NOTICE OF A TYPE II DECISION ON A PROPOSAL IN YOUR NEIGHBORHOOD

CASE FILE NUMBER: LU 15-199413 AD

Site Address: 1235 SE REYNOLDS ST

The applicant has converted a detached garage into an accessory dwelling unit (ADU). The ADU maintains the footprint of the garage, but a (108 square foot) second story loft was added when the structure was converted; this loft is proposed to be removed. The total floor area of the ADU is 200 square feet.

CASE NO. LU 15-199413 AD
 EXHIBIT C-1

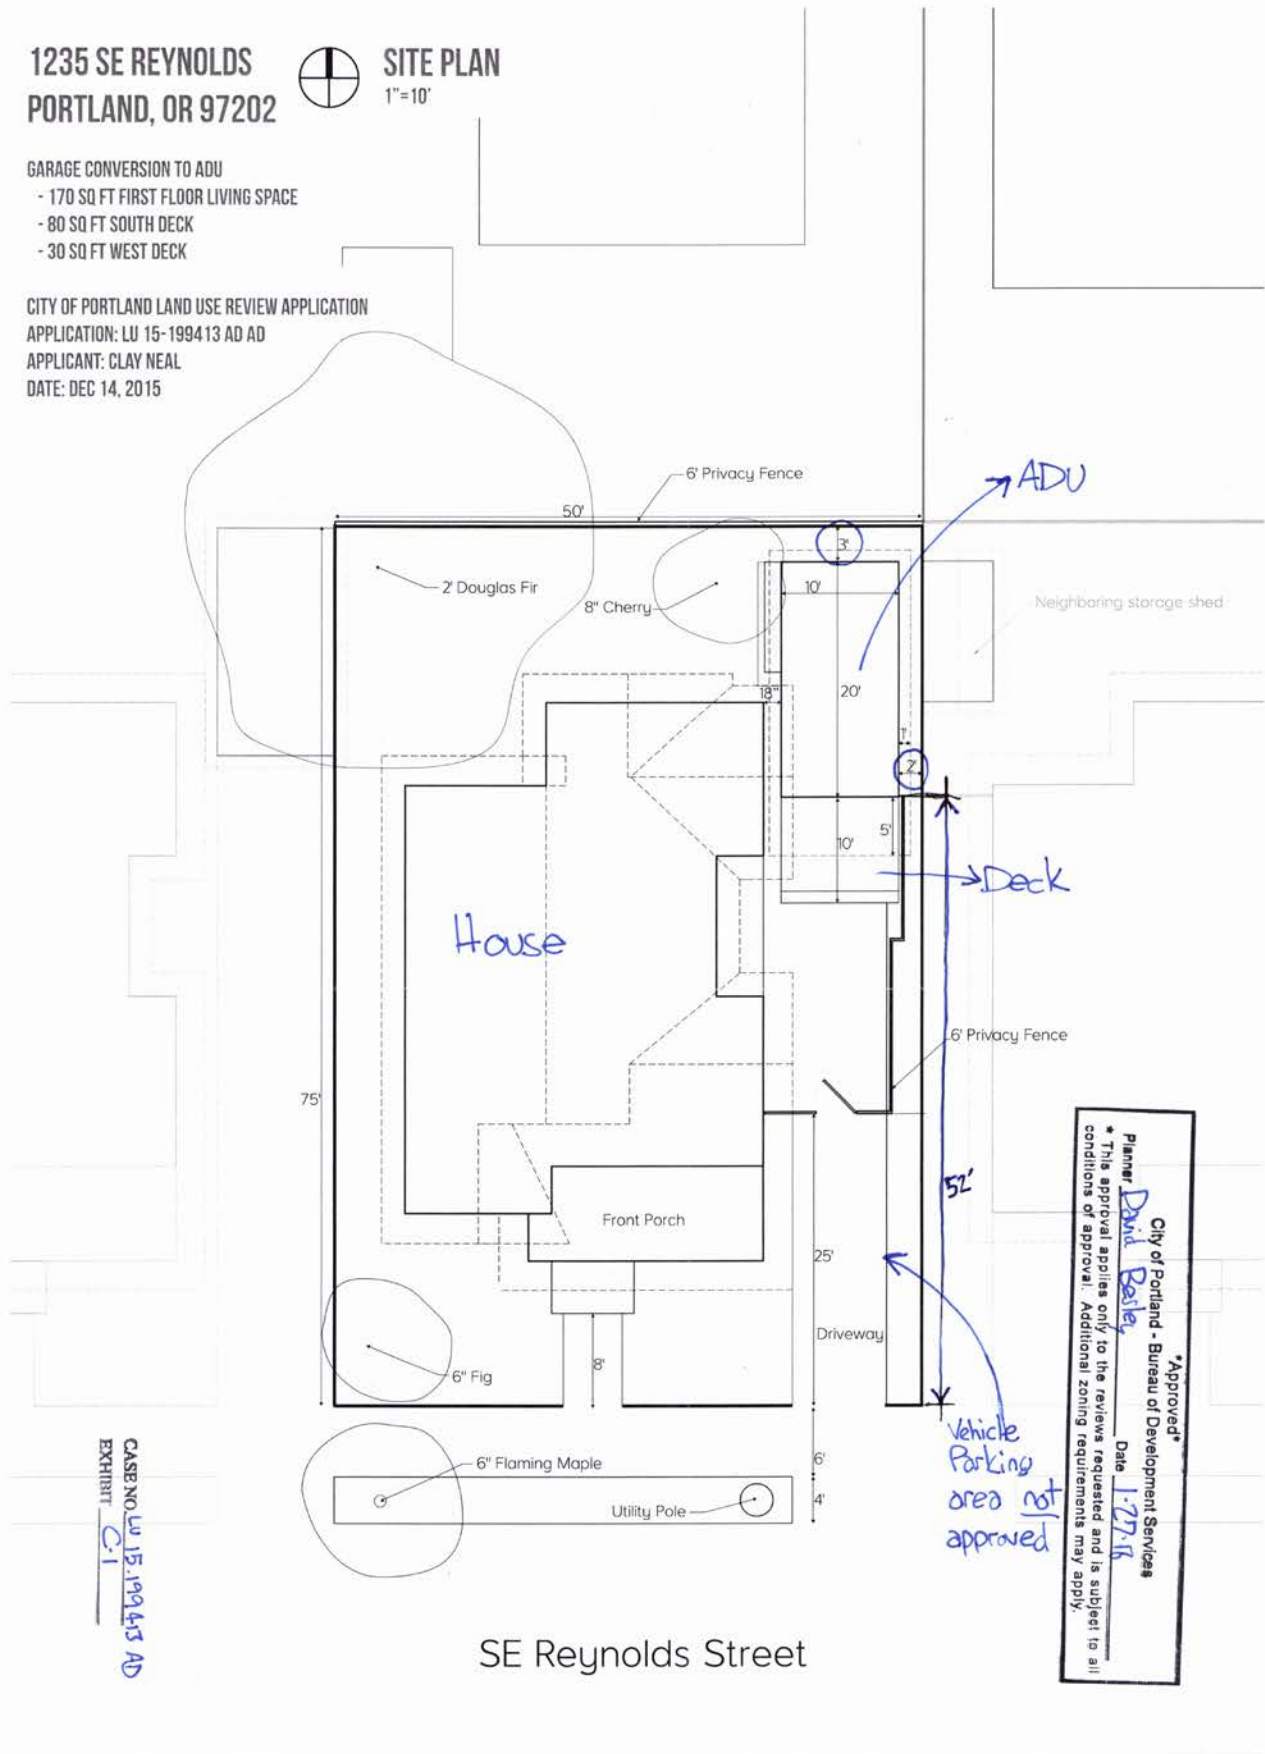
Note: This Adjustment approval and approved site plan does not approve the vehicle parking area as shown. Parking is not allowed within the first 10 feet from a front lot line (33.266.120.C.1.a) and the standard parking space size for a house is 9 feet by 18 feet (33.266.120.D.1). There is a fence at 25 feet from the front lot line which must be shifted at least 3 feet to the north (for a minimum 28 feet in length) to accommodate parking requirements. At the time of building permit submittal, the applicant must include a revised site plan to reflect vehicle parking changes.

CASE NO. LU 15-199413 AD
 EXHIBIT C.2

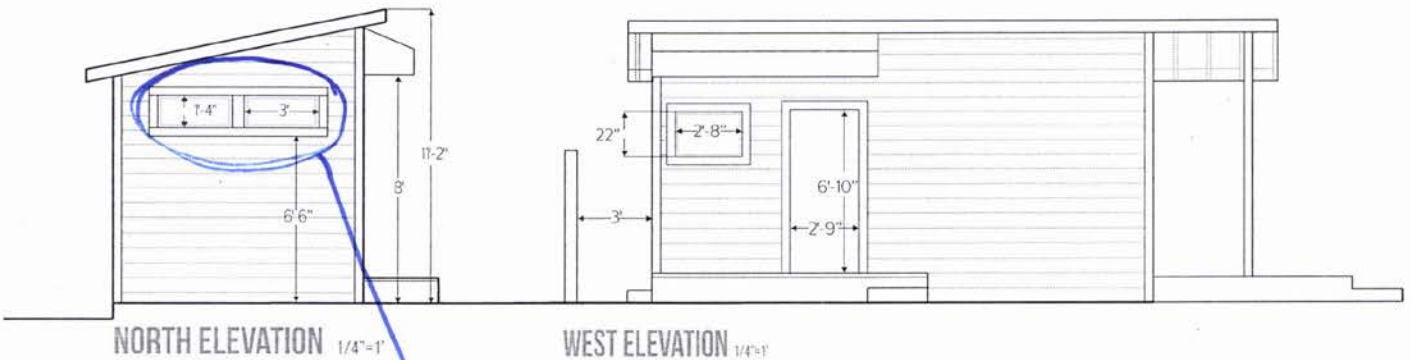
Unless the applicant can demonstrate that the north wall is farther than 3 feet from the property line, the two windows proposed on the north elevation will likely have to be removed because wall faces that are 3 feet or closer must be fire rated and cannot have openings (including windows).

wall faces 3' or closer
 must be fire rated
 and cannot have openings
